SMITHMOOR 10TH ADDITION TO SEDGWICK COUNTY, KANSAS

SUB 2001-42 -- One-Step Final Plat of Smithmoor Tenth Addition

SUB 2000-42 -- One-Step Final Plat of Smithmoor Tenth Addition

CASE NUMBER: SUB 2001-42 -- SMITHMOOR TENTH ADDITION

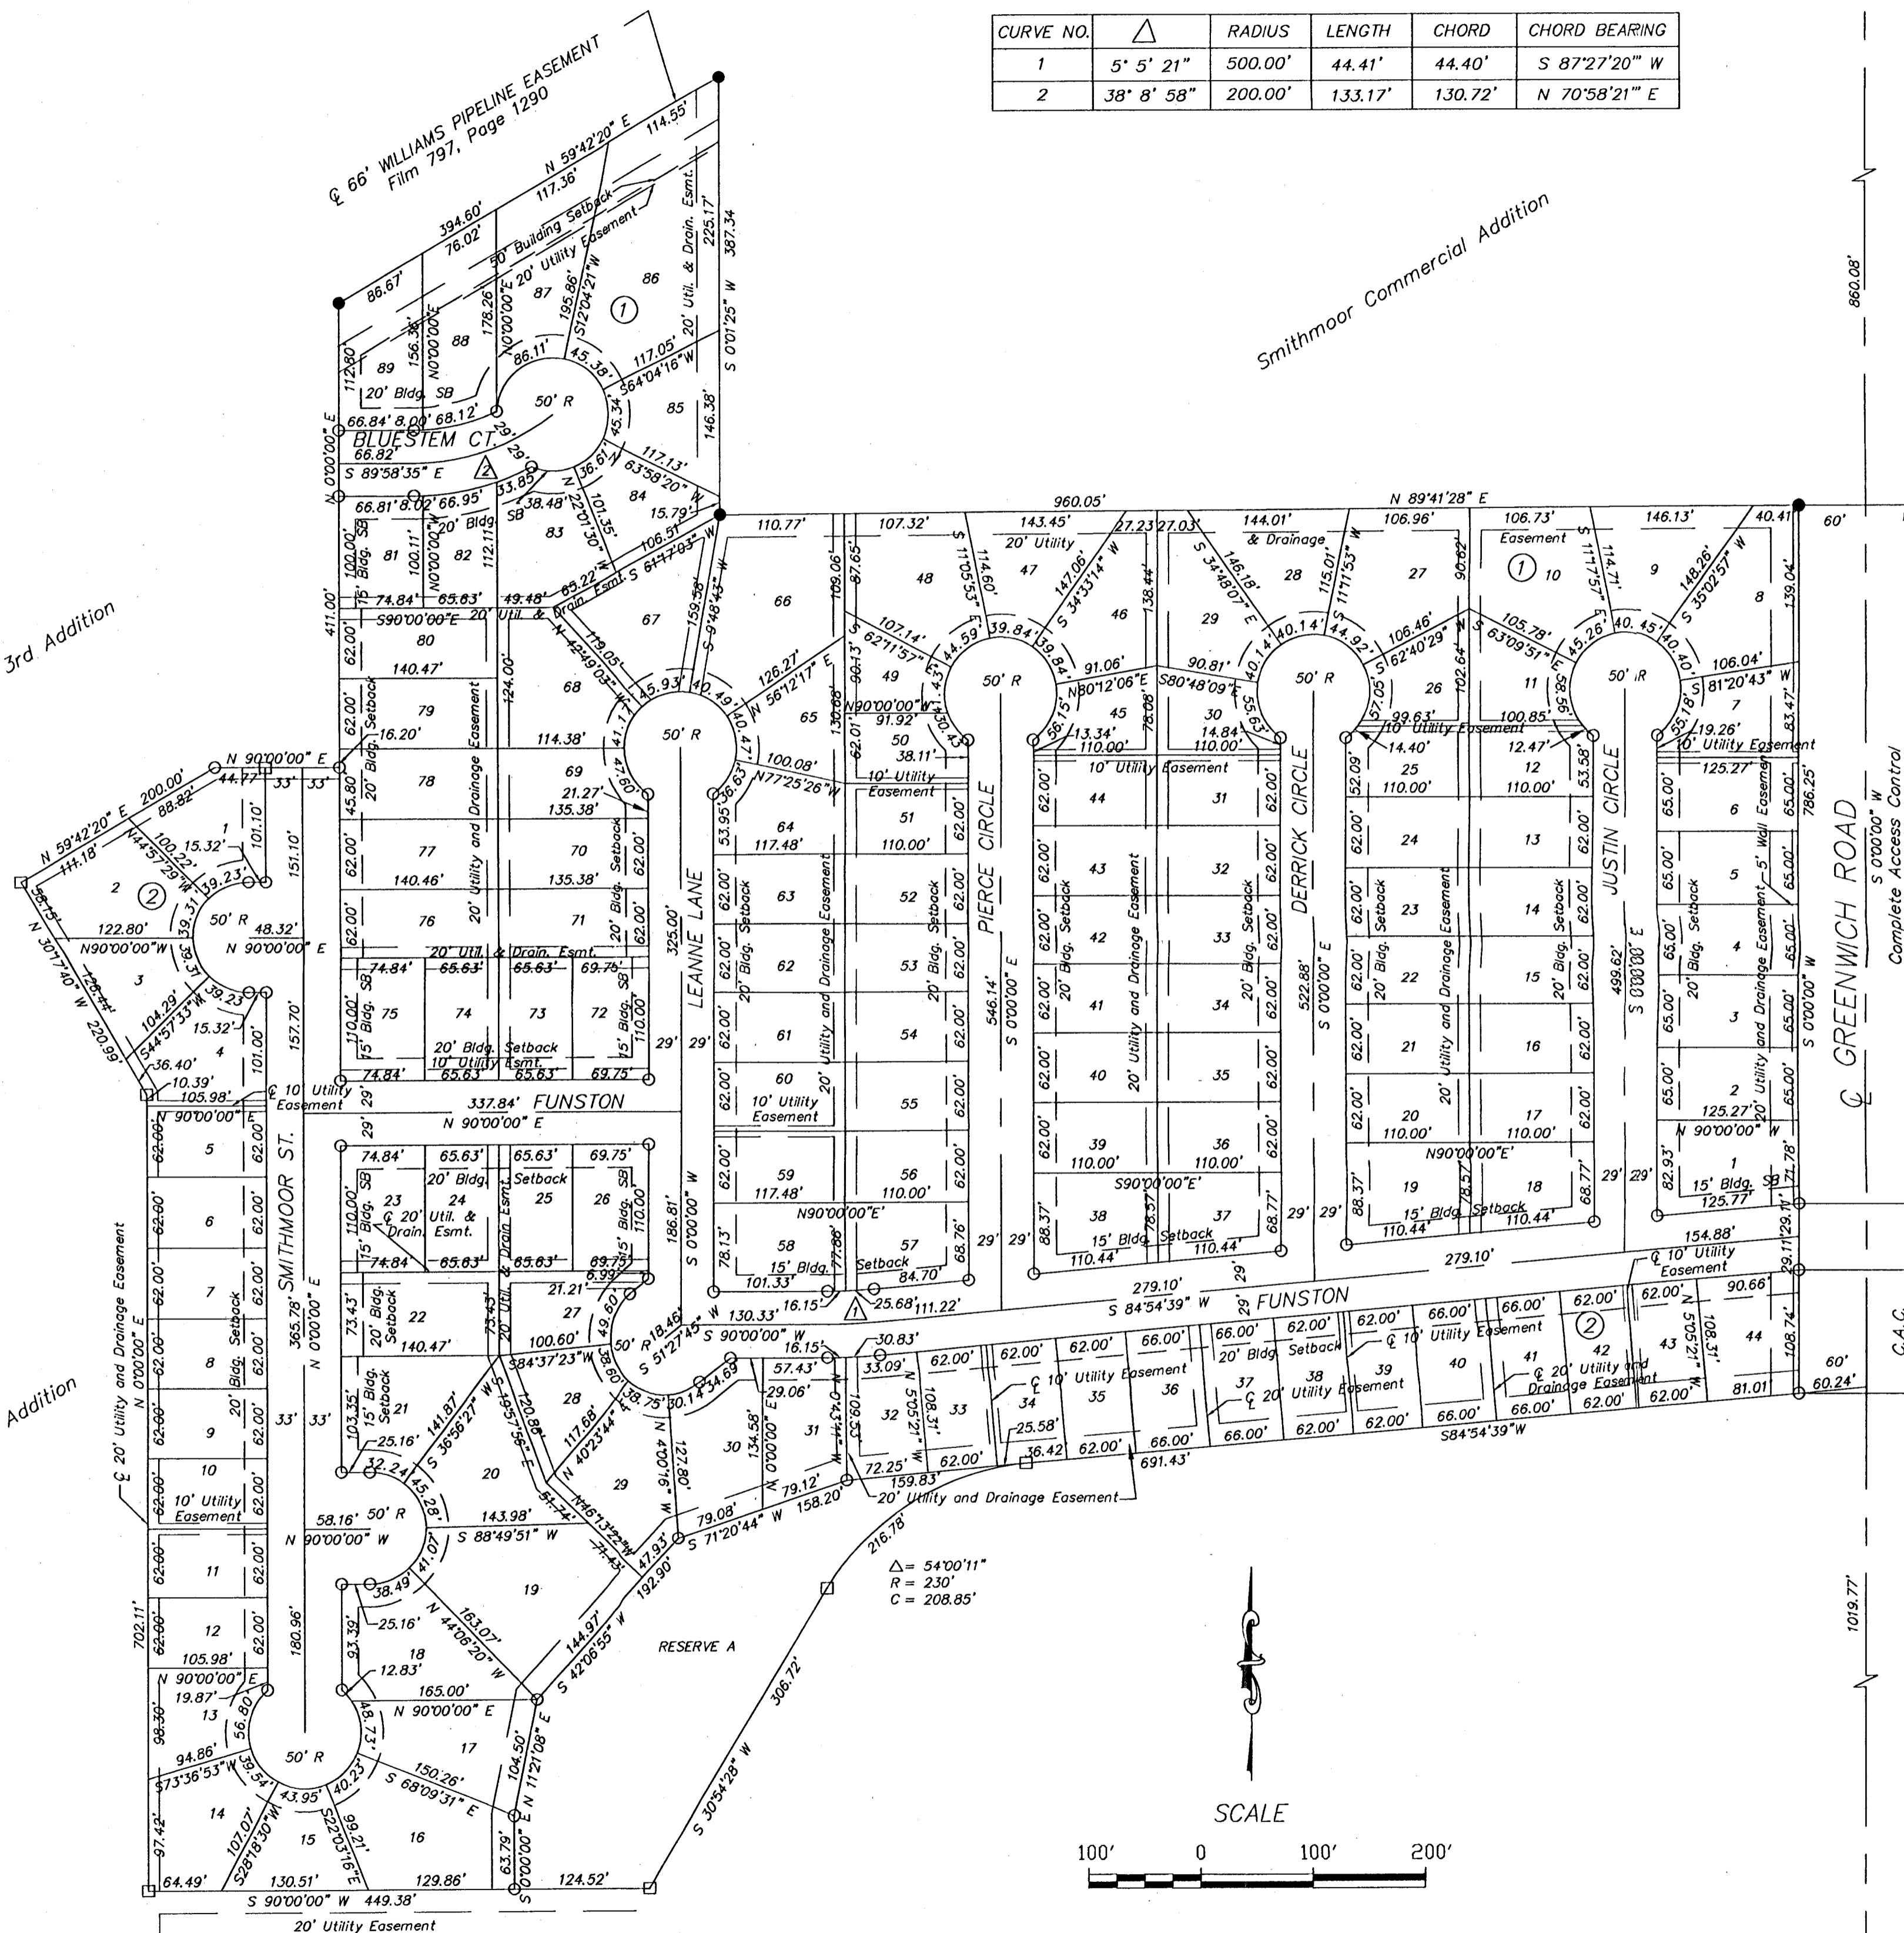
- D. City Engineering needs to comment on the status of the applicant's drainage plan. *The drainage plan is approved; although revisions are needed.*
- E. The plat should dedicate complete access control along Greenwich. The final plat tracing shall reference the access controls in the plat's text.

- L. The City Fire Department needs to comment on the plat's street names. The street names are acceptable.
- M. Various utility, wall and drainage easements that are labelled need to be platted.

- O. The wall easement needs to be referenced in the plattor's text.
- P. The reference in the plattor's text regarding temporary cul-de-sac easements is not portrayed on the drawing, and may be omitted.

- Q. The reference in the plattor's text to "repairing public street" needs to be omitted.
- R. The applicant has platted 20-ft building setbacks which represents an adjustment of the Zoning Code standard of 25 feet for the SF-6, Single-Family District. The Subdivision Regulations permit the setback provisions to be modified by the plat upon the approval of the Planning Commission. The Subdivision Committee recommends that the setback provisions be adjusted.

- T. The applicant's agent shall determine any setback requirements for the pipelines by researching the text of the pipeline agreements. If a setback from the pipeline easements is provided for in the pipeline easement agreements, it shall be indicated on the face of the plat.
